August 1ST, 2022

MCQV3 / MCQI3 Needle valve design change Notification

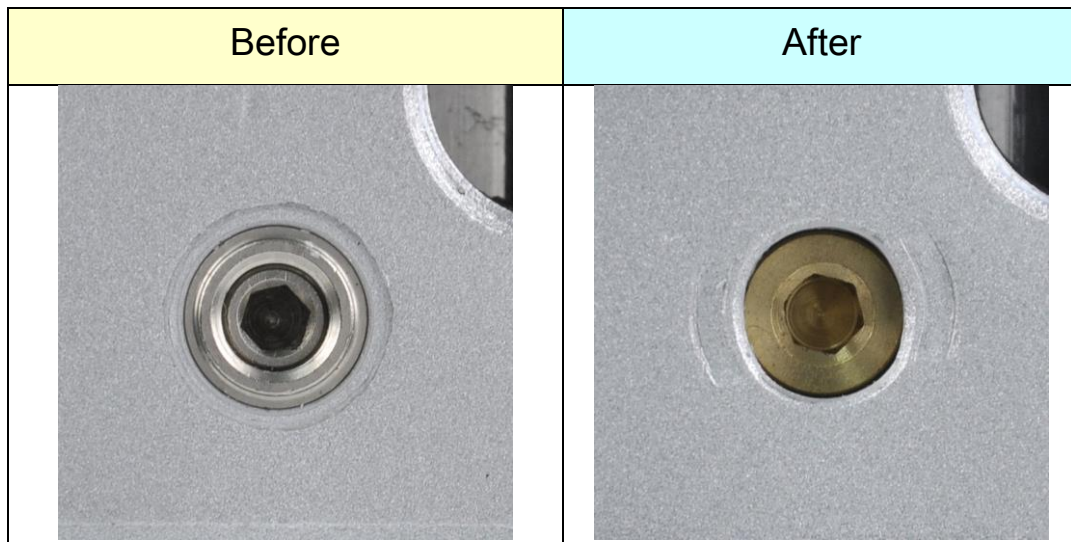
1. Model series
MCQV3/MCQI3-Ø63
2. Design change reason
Change the design of the flow adjuster for a more precise flow rate adjustment.
3. Change descriptions
